From: Philip Barrett
Sent: 5 Dec 2019 14:52:29 +1300
To: Cameron Aplin;malcolm.brown@waidc.govt.nz
Cc: Sharon Singleton;Graham Singleton
Subject: G & S Singleton -Extra Flood Hazard Analysis and Waikato Regional Council Consultation Reply
Attachments: IMG_0160.JPG, IMG_0162.JPG, IMG_0161.JPG, SWMP Issues Memo.pdf

Response to Stormwater Management Plane Issues

Westlands Subdivision

A meeting was held on Monday 25th November 2019 to discuss the nine issues raised by the Beca Review. This is a summary of the extra work undertaken by Golovin.

Figure 2 – Lot 7 raised driveway HGL

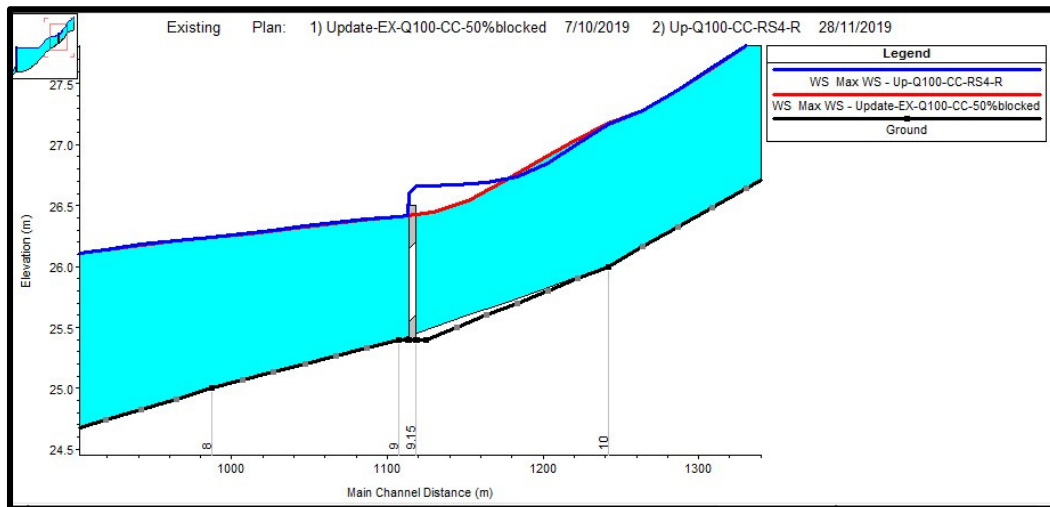
- *The effect of the ROW. Does it flood in the 100-year event? If it needs to be built up what impact does it have on the floodplain?*

There are two locations where the roadway is within the 100-year floodplain. It is Waikato District Council desire that the roadway be at or above this level.

For Lot 7 the driveway cuts across overland flows. The ground level is about RL26m and the flood level is RL26.4m. This suggests a 400mm raising of the driveway. This may have an impact for the neighbours at Lot 39 DPS 76270 and Lot 1 12807. RS9 was adjusted by inserting a nominal 600mm culvert and driveway at RL26.5m. Figure 2 shows the change in HGL. Although the water level rises to get over the driveway the influence at RS10 diminishes to zero. This location is the neighbouring upstream boundary.

In conclusion, raising the roadway in Lot 10 requires the FFL of Lot 1 to be raised by 30mm. Within Lot 7 a culvert needs to be under the driveway to drain the area but its design and raised driveway does should not affect neighbouring properties.

Figure 3 – Lot 1 subcatchment

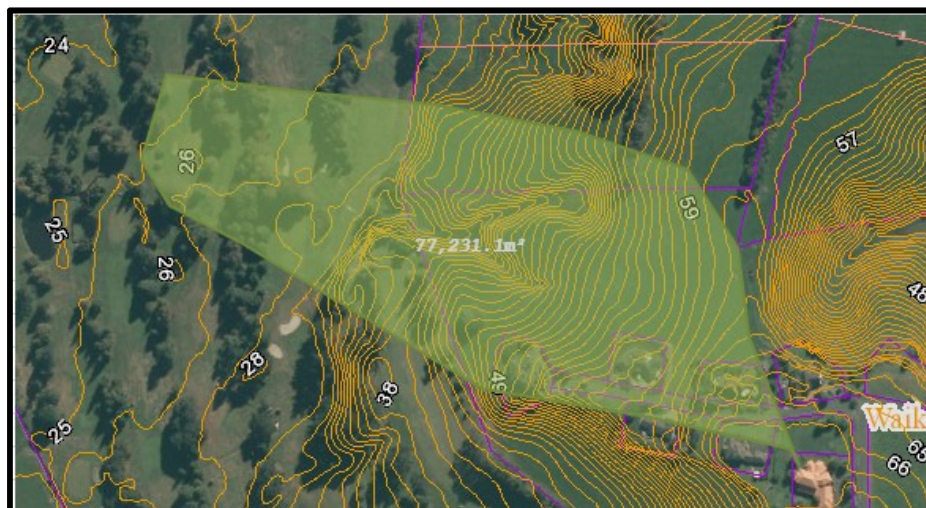
- *Impact for each of the proposed house locations by the overland flowpath. Do the FFLs need to be raised above “normal” ground levels?*

The catchments for Lots 1 and 7 were analysed. The lot 1 catchment is the largest example for houses in Lots 2, 3, 4, 5 and 10. While Lot 7 has a catchment size based on the adjacent drain. These are shown in Figures 3 and 4.

At Lot 1 if the flow width is 24m or more the depth of flow is less than 100mm. For Lot 7 it is 23m. Close examination of the ground profiles there is no concentration of flows but general sheet flow. The widths of the Lots are about 40-50m and therefore the flow depths will be less than 100mm and the allowance for OLFP is within the normal building regulations for ground clearance.
